Exhibit 2.2

Marsh Creek Matrix of Required Retrofits to Public and Common Use Areas

MARSH CREEK APARTMENTS: PUBLIC AND COMMON USE AREAS

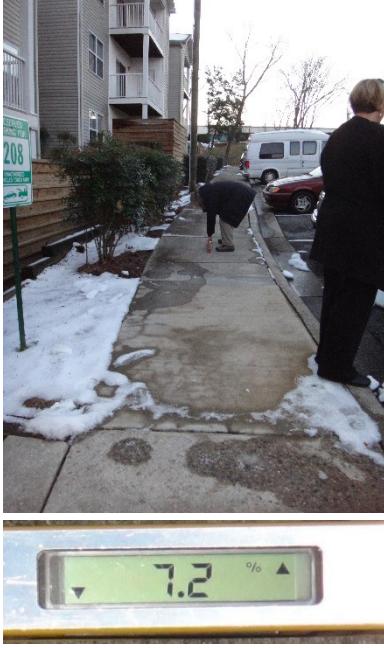
Numbers	Lack of Accessible Route	Deficiency	Required Retrofit
7	  <i>Curb ramp leading towards Building 2.</i>	<p>Curb ramp cross slopes are more than 2.0% (maximum 2.0% allowed).</p> <p><u>Location</u></p> <p>North of entry drive 3.5%</p> <p>At leasing office 5.9%</p> <p>Bottom of curb ramp at south end of entry drive 13.3%</p> <p>Entry drive, west of trash dumpster 7.8%</p>	Modify 3.5%, 5.9%, 13.3%, and 7.8% cross slopes to comply with ANSI 4.3.7.
8	 <i>Light fixture at entrance to leasing office.</i>	The light fixture at entrance to leasing office protrudes approximately 5 inches into the circulation path (maximum 4 inches allowed).	Modify protruding objects that project more than 5" into the circulation path to comply with ANSI 4.4.1.
